**Site Formation and Infrastructure Works  
for Public Housing Development near Tan Kwai Tsuen,  
Yuen Long – Investigation, Design and Construction**

**FINAL WATERWORKS  
IMPACT ASSESSMENT  
REPORT FOR S16 PLANNING  
APPLICATION  
(INTENSIFICATION SCHEME)**

**Responses to Comments on  
Final Water Impact Assessment Report for S16 Planning Application  
(Intensification Scheme) (Issue 1)**

Drawing No.	Scale
199086/BIN/WIA/015	1 : 1000 (A1) 1 : 2000 (A3)

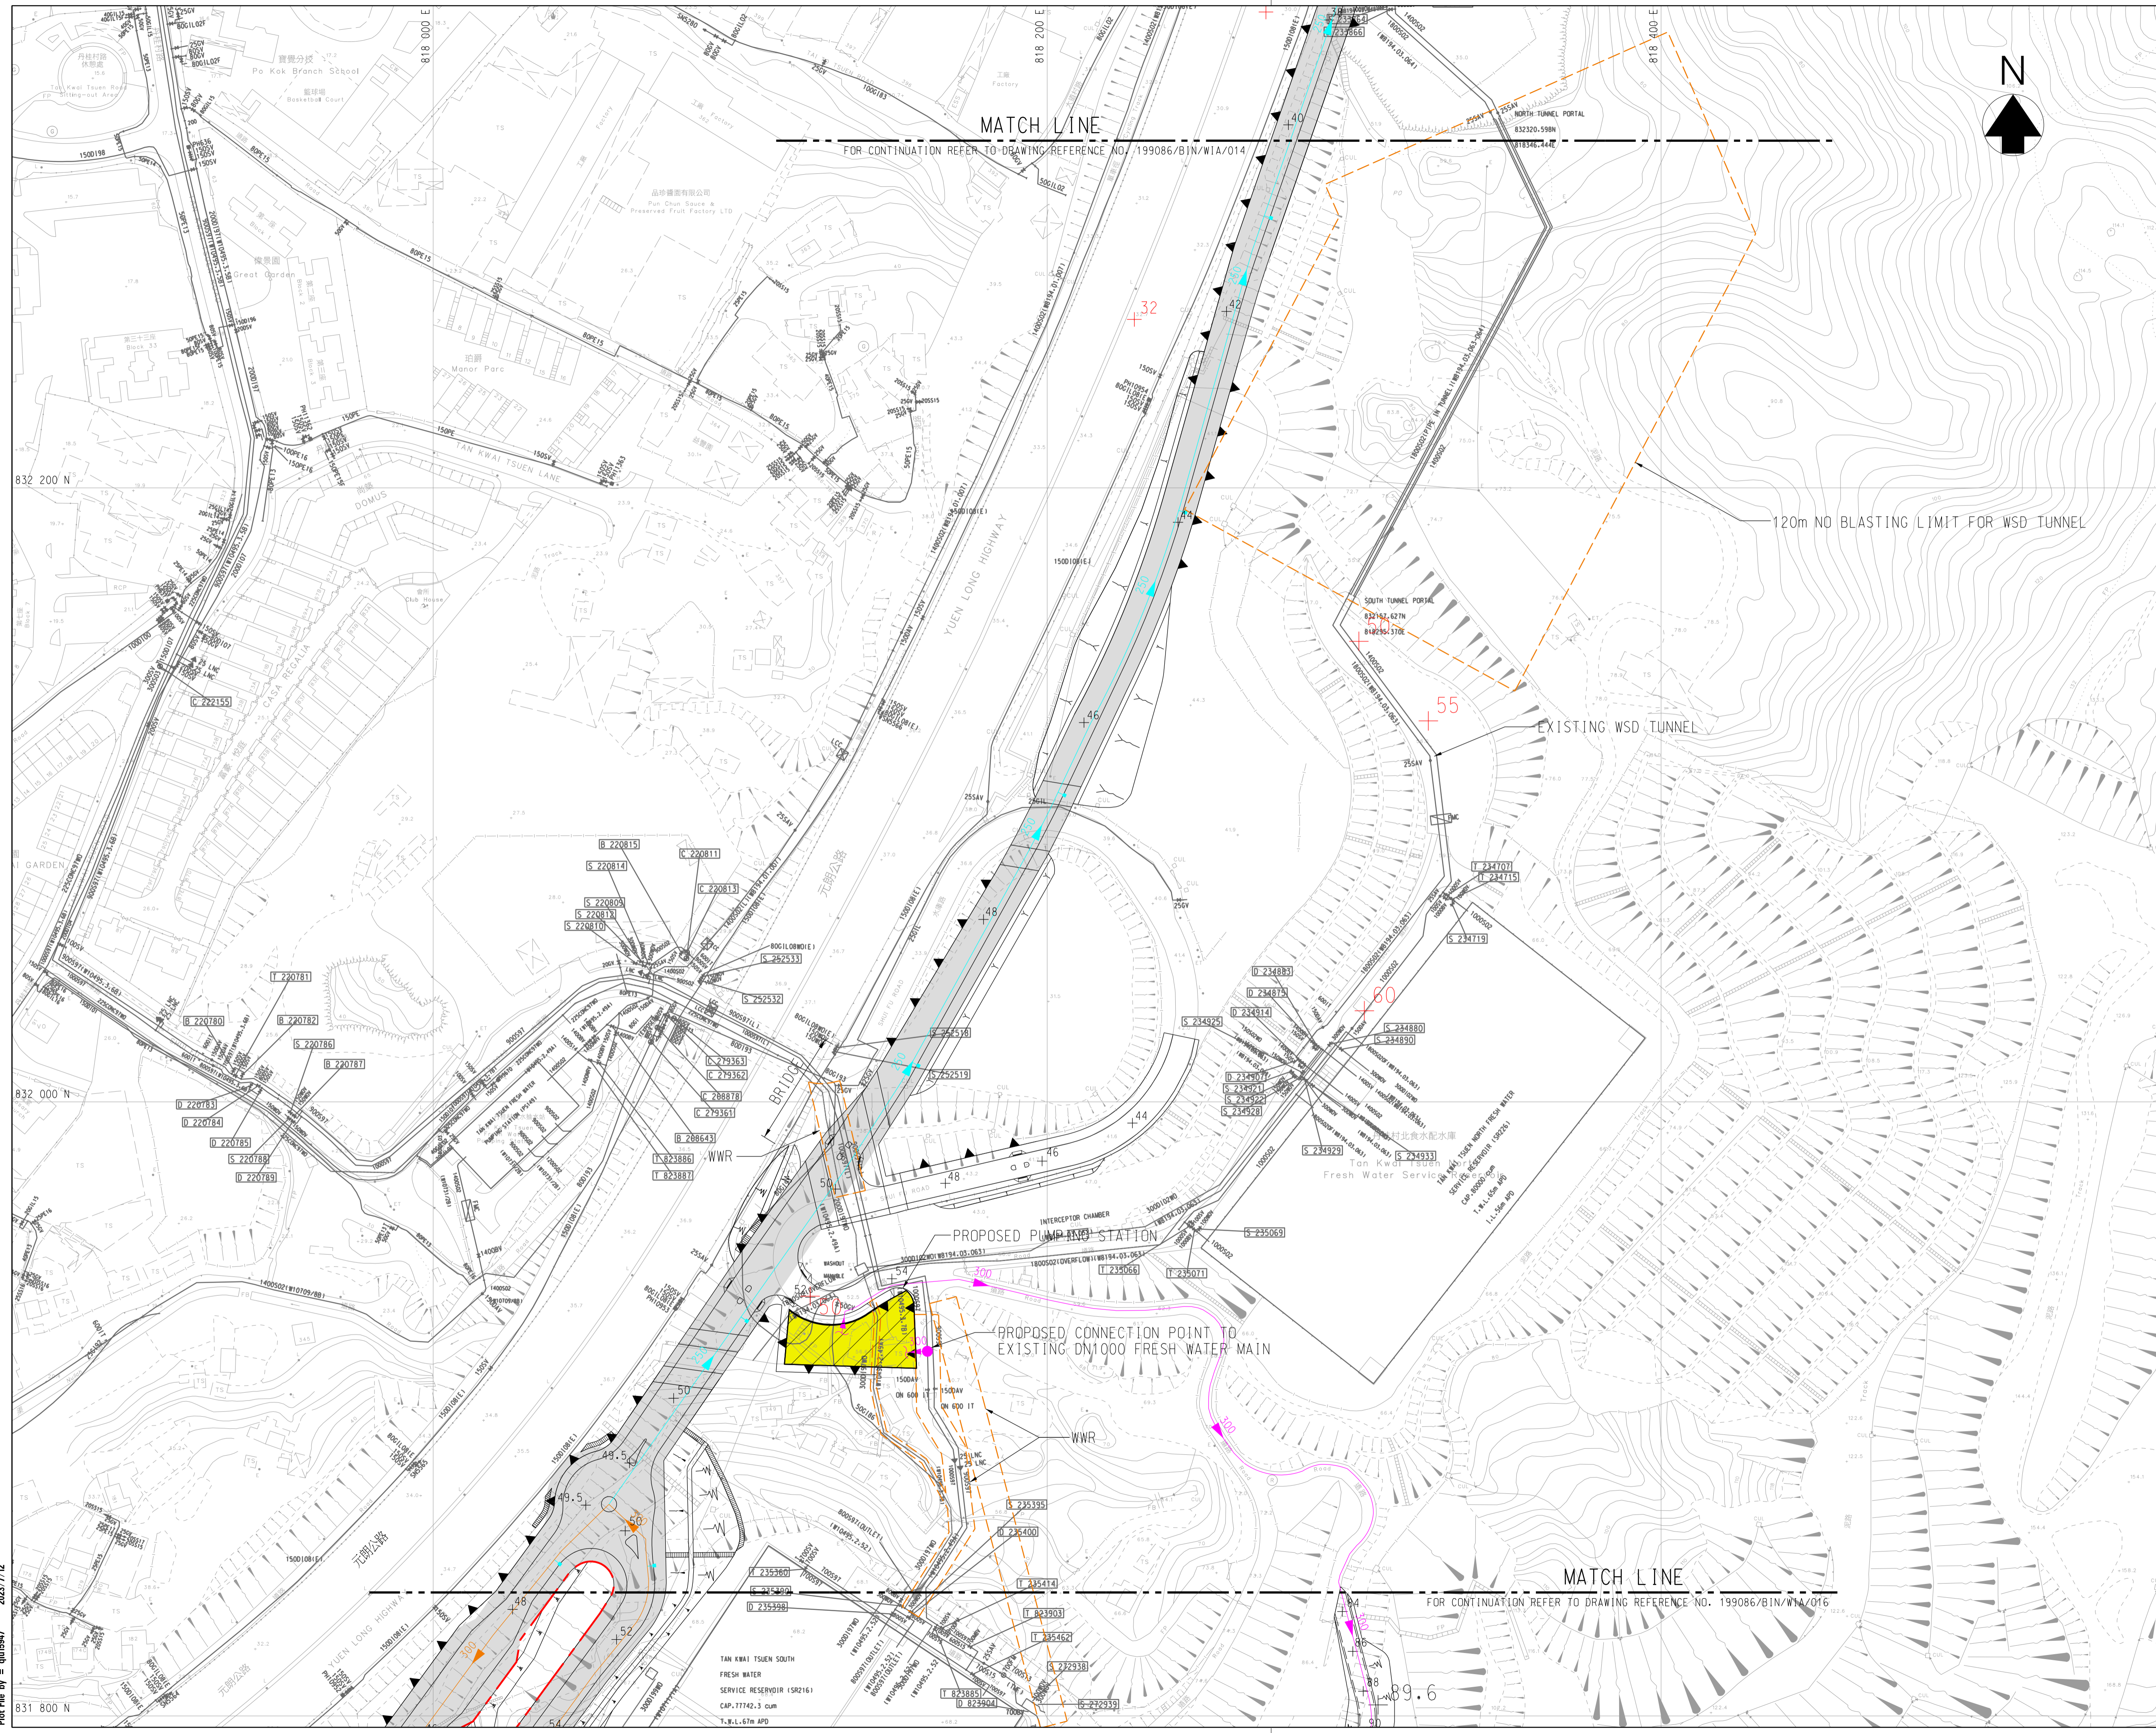
5. 199086/BIN/WIA/015 - the size of the proposed DN600 inlet and outlet pipes of the proposed pumping station seem to be on the high side. Please review with respect to the comments on Appendix G.	Noted and revised accordingly. The inlet and outlet of pipes size are revised to DN450 accordingly, please refer to updated drawings 199086/BIN/WIA/015.

Drawing No.	Scale
199086/BIN/WIA/017	1 : 1000 (A1) 1 : 2000 (A3)

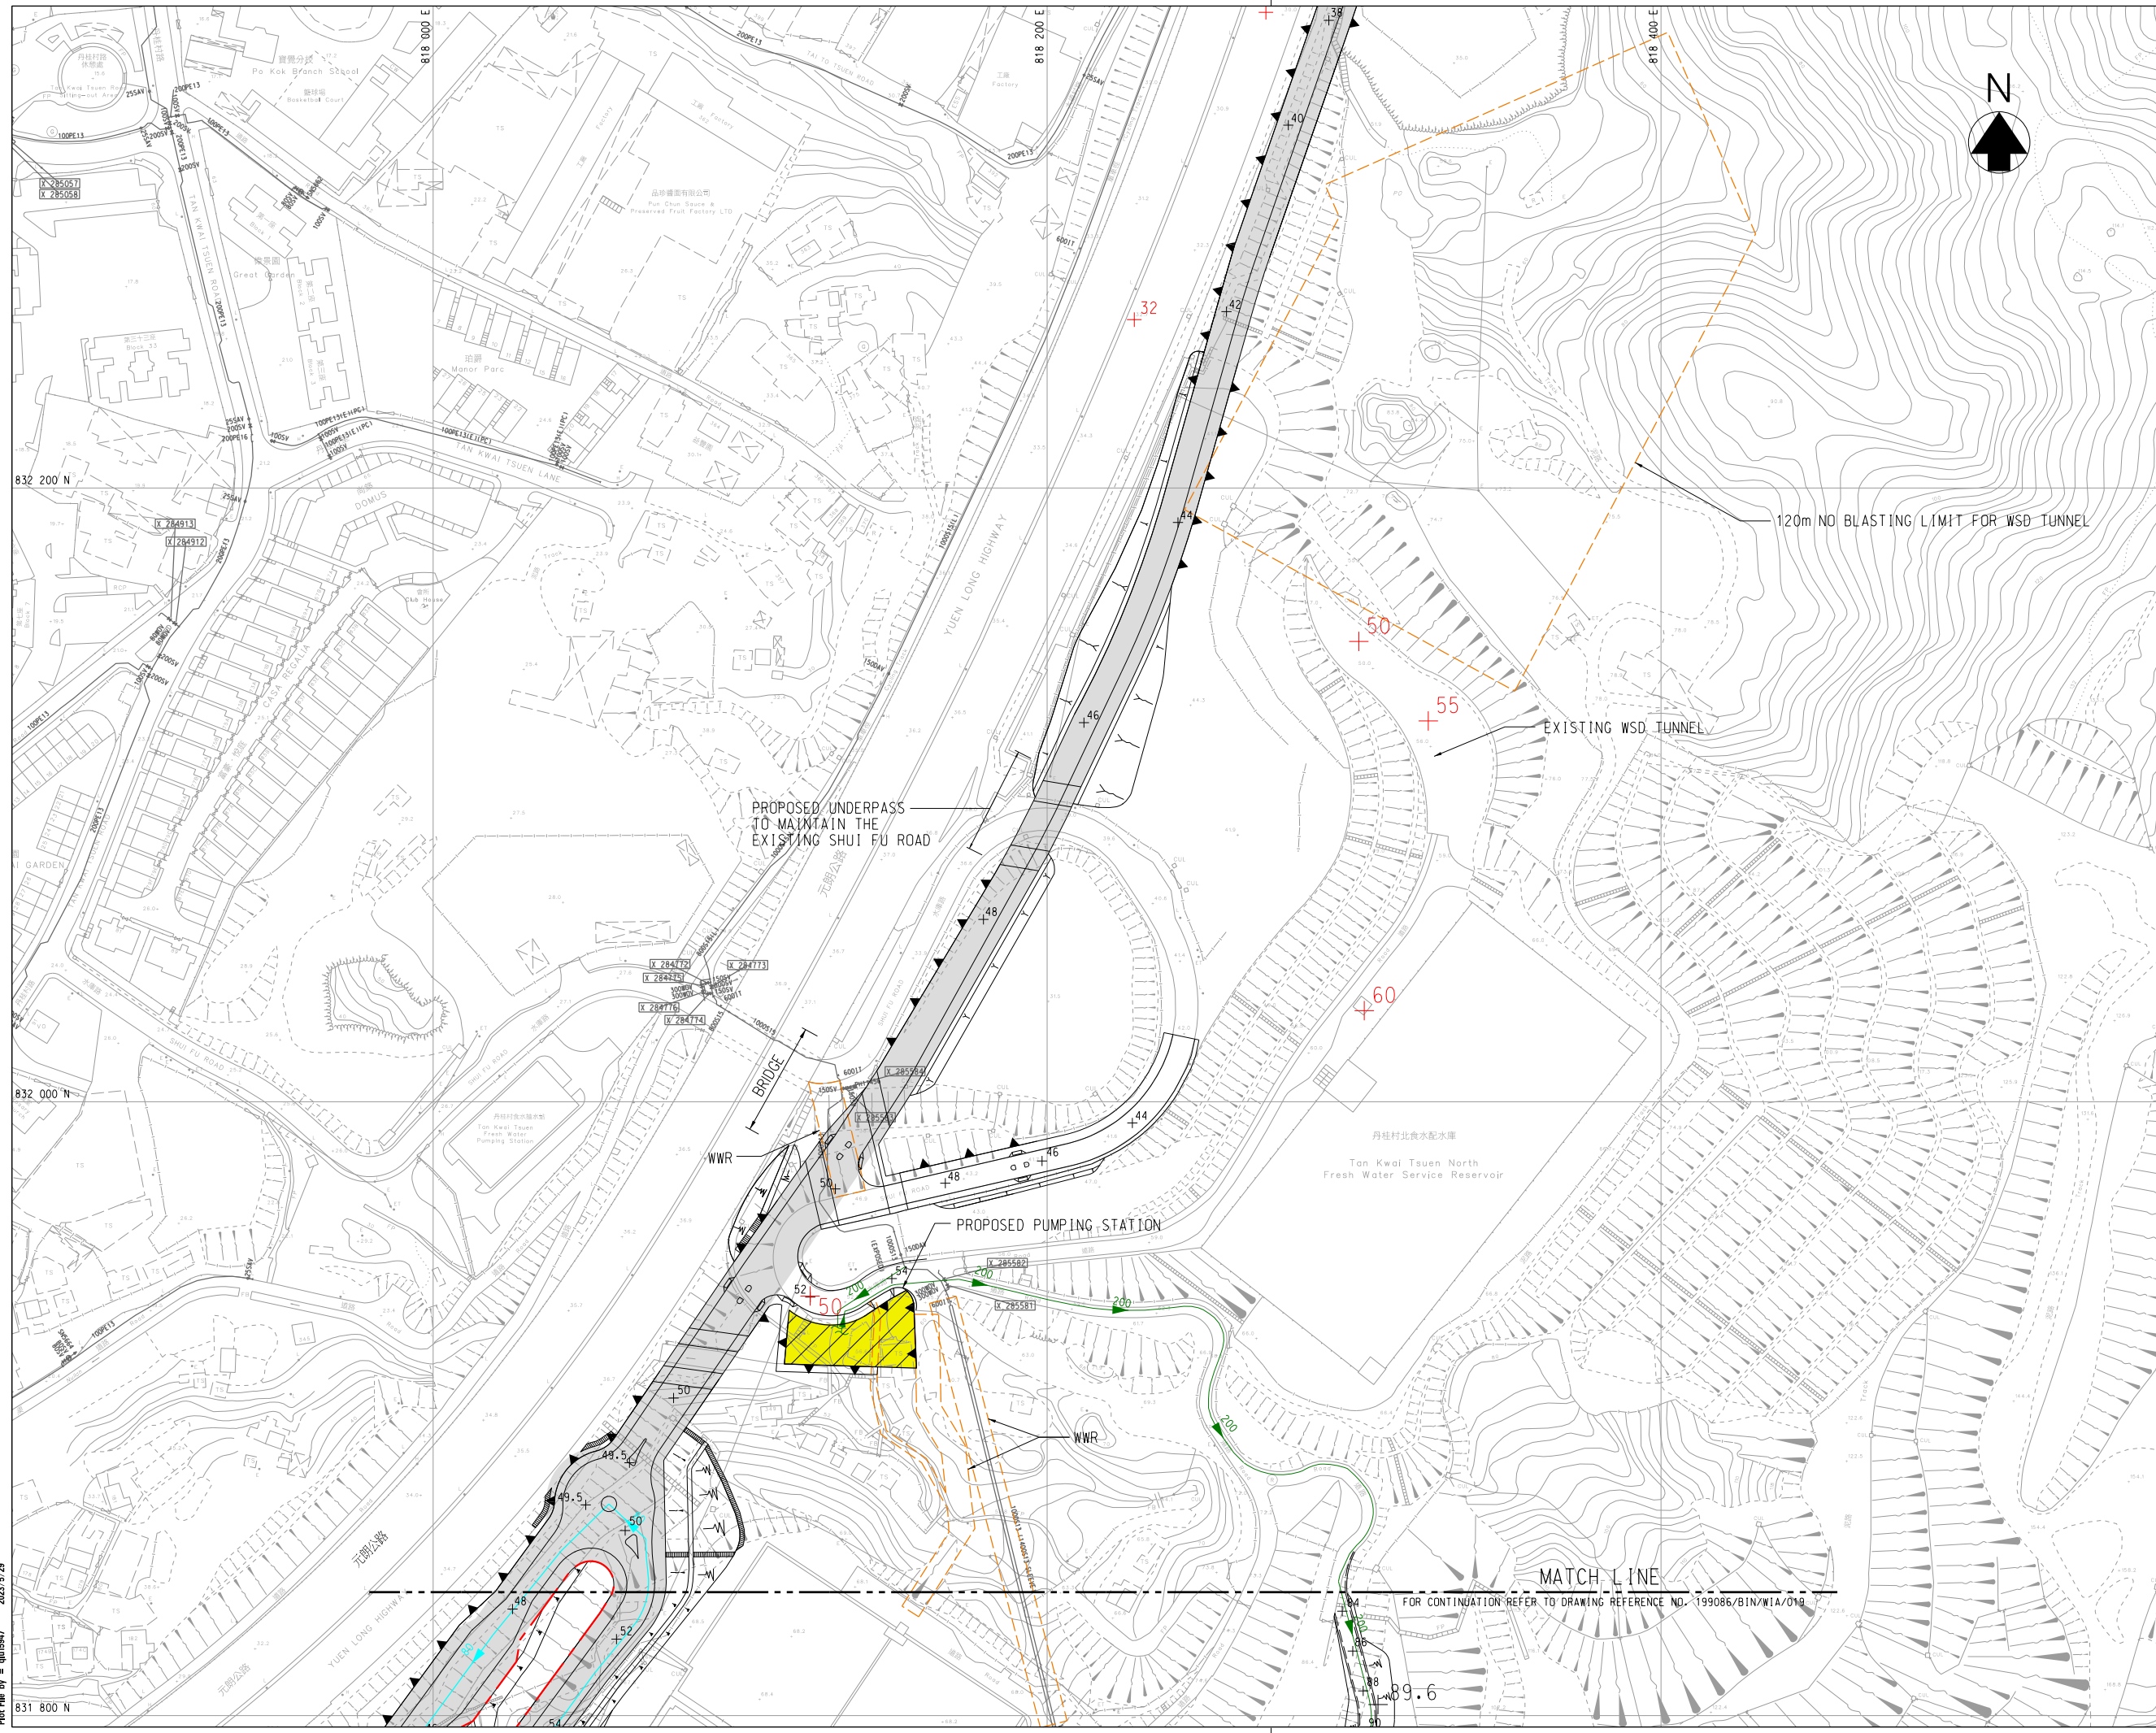
Comments	Responses
<p>In consultation with our works agent, ArchSD, please adjust the location of the water mains lead-in, flush and fresh water connection. All lead-in and underground pipes should be placed away from the run-in/out of the school site. Due consideration should also be given to other utilities. The waterworks proposals shown in the report under the application have not addressed the comments that are provided to CEDD via email dated 28 June 2022.</p>	<p>Noted and revised accordingly. Please refer to revised Drawing no. 199086/BIN/WIA/017.</p>
